Shearwater Teric Firmware Release Notes

VERSION 19 2021-07-21

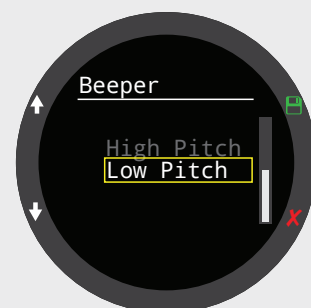
NEW Translated versions. Currently available for:

- 繁體中文 (Traditional Chinese)
- 简体中文 (Simplified Chinese)
- 日本語 (Japanese)
- Español (Spanish)
- other languages will be added once ready

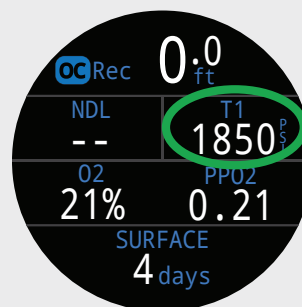
NEW Lower frequency option added for beeper, which may be easier for some users to hear.
